Access Compliance Report

Public Rights-of-Way (Curb Ramps)

Intersection ID: 25204	Main Street: BRIDLE_BROOK_WY	Cross Street: RETANA_DR	Location: NW
ADA ID: EA6912A9A6F9	Ramp Type: BlendTrans1	Initial Pass/Fail: Fail	Overall Compliance: No
Severity Score: 25			
Codes/Mitigation Info/Possible Solution		Field Measurements/Component Compliance

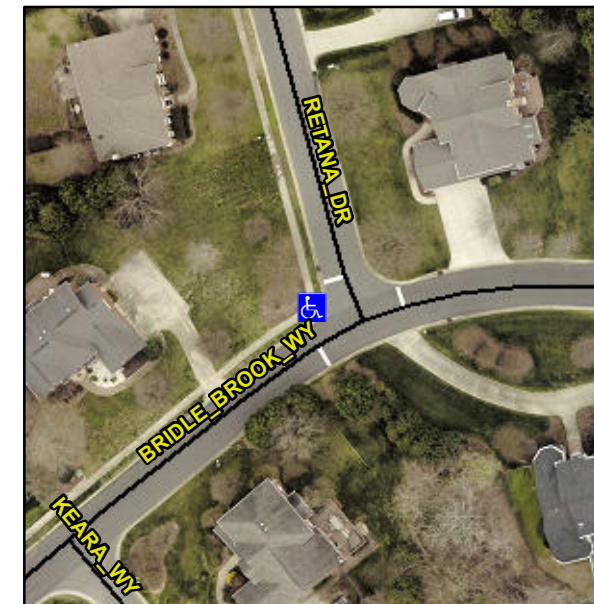
Not Found, R304.5.3

Compliance	Description	Data	Compliance	Description	Data
N/A	Ramp Length (in)	50.5	Yes	BlendTrans Slope (%)	3.6
Yes	Ramp Width (in)	48.0	No	BlendTrans XSlope (%)	7.8
N/A	Flare Type LT	N/A	N/A	Flare Type RT	N/A
N/A	Flare Slope LT (%)	N/A	N/A	Flare Slope RT (%)	N/A
N/A	Flare Traversable LT?	N/A	N/A	Flare Traversable RT?	N/A
N/A	Landing Length (in)	N/A	N/A	DWS Provided?	N/A
N/A	Landing Width (in)	N/A	N/A	DWS Contrast?	N/A
N/A	Landing Slope (%)	N/A	N/A	DWS Length (in)	N/A
N/A	Landing X Slope (%)	N/A	N/A	DWS Full Width?	N/A
N/A	Landing Curb? (Y/N)	N/A	N/A	DWS Offset (in)	N/A
N/A	Shared Landing?	N/A			
N/A	Gutter Ponding?	N/A	N/A	Gutter Slope (%)	N/A
N/A	Gutter Lip Ht (in)	N/A	N/A	Gutter X Slope (%)	N/A
N/A	Painted X Walk1?	No	N/A	Painted X Walk2?	No
	X Walk 1 Direction	To S		X Walk 2 Direction	To E
	X Walk 1 Width (in)	N/A		X Walk 2 Width (in)	N/A
	X Walk 1 Slope (%)	N/A		X Walk 2 Slope (%)	N/A
	X Walk 1 X Slope (%)	N/A		X Walk 2 X Slope (%)	N/A

N/A	Ramp inside XWalk1?	N/A	N/A	Ramp inside XWalk2?	N/A
	Road Slope (%)	4.0		Clear Space?	N/A
	Road X Slope (%)	4.5	N/A	Clear Space to XWalk (in)	N/A
N/A	Any Obstructions?	N/A	N/A	Storm Grate/Utility Hazard?	N/A
	Obstruction Type			Storm Grate/Utility Type	
		N/A			N/A
			Yes	Surface Condition? (G/P)	Good
			No	Curb Slope (%)	7.6

Remove & Replace Curb Ramp With Two New Directional Ramps or Equivalent.
